Request for further information in accordance with section 92 of the Resource Management Act 1991

Notice of requirement: Watercare Services Limited – **Whenuapai & Redhills Wastewater Scheme**

Figure 3. Considerations for pump station and gravity pipeline location

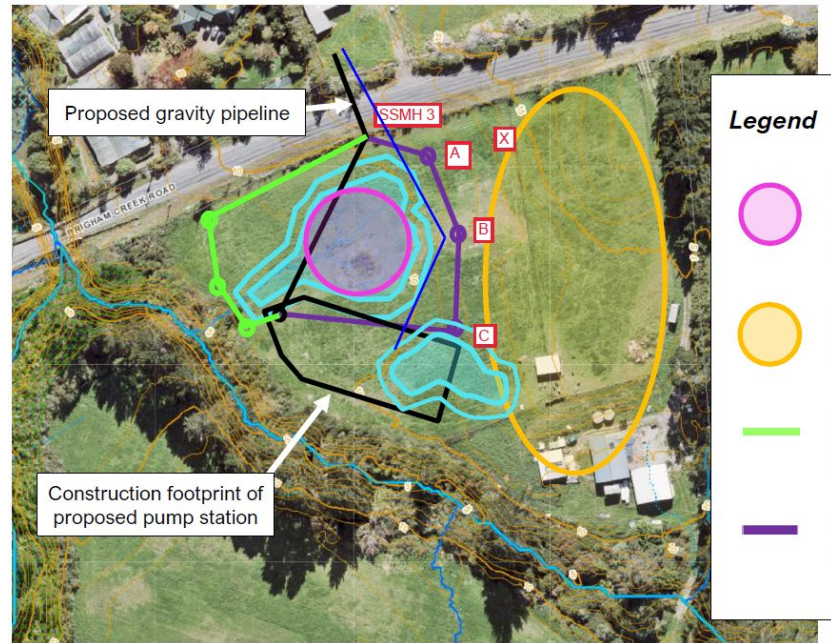
The Requiring Authority states that this will make the pipeline 3 metres deeper, and that the construction would then be 7m deep.

However, from the above, 'Manhole A' is shown on the 11m contour, manhole B is at about 11.7m and manhole C about 11.5m, but this is at a completely unrealistic location as it should be further to the west. From the design drawing MH, manhole 'A' would have an invert level of

#	Category of information	Specific Request – 13 November 2023	Reasons for request – 13 November 2023	Additional information request – 09 February 2024
		<p>about 6.70m. Therefore the depth of this manhole would be around 4.3m.</p> <p>This is a long way short of the stated 7.0m. For manhole 'A' to be at 7m deep it would need to be at RL 13.7; or around Location X.</p> <p>At a depth of 4.3m a trench shield can be used to minimise trench width, and therefore benching is unlikely to be required. Therefore the alignment shown, could likely move closer to the wetland, noting also the difference between the wetland boundary and the 1% AEP boundary. This would potentially mean that the 4.3m depth is likely to be less than 4m if the Requiring Authority were to attempt to make this design efficient.</p> <p>It is noted that throughout the alignment most manholes and trench lines are around 3m deep, so a 4m deep manhole is not exceptional.</p> <p>The deepest manhole is SSMH-4 at about 5.5m. It is noted that SSMH-3 if left in its current position, would likely need to be raised to the same depth due to the widening of Brigham Creek Road.</p> <p>The Requiring Authority state that an eastern alignment would require 3 additional manholes. However, it would be perfectly feasible to have an alignment from SSMH-3 to approximately 'B', and then into the WSL owned land, which would then only require one additional manhole. Alternatively, laying away from the BCR crossing</p>

#	Category of information	Specific Request – 13 November 2023	Reasons for request – 13 November 2023	Additional information request – 09 February 2024
		<p>without installing SSMH-3, could allow for no additional manholes, and remove the need for the extra deep SSMH-3.</p> <p>It is possible to reposition the pump station structures, including the inlet manhole based on what suits an eastern route, so the assumption of a western inlet manhole gives the longest possible gravity pipe, but this could be shorter. A rearrangement of pump station structures may be necessary anyway due to the discovery of Wetland D. This may also shorten the rising main length which would be a positive benefit, and offset any additional length of gravity main, which is likely to only slightly add to the depth of the station. If this were really a substantial factor, WSL could look at 'shallowing up' opportunities back at the existing pump station area.</p> <p>Therefore, I have concerns that the location of the pump station is not supported by a functional requirement assessment that demonstrates that alternative locations aren't possible.</p>

ENG1	Engineering	Can you please consider the comments above, and reconsider the functional requirement for the location East of the wetland. Please include pipe route, including consideration of rearranging	<i>To ensure a complete assessment has been considered.</i>	<i>The response has provided some detail, but does not provide any clarity or information if the rearrangement of the structures were considered. Did the Requiring Authority consider a different layout of structure(s) on the site? If not why not?</i>
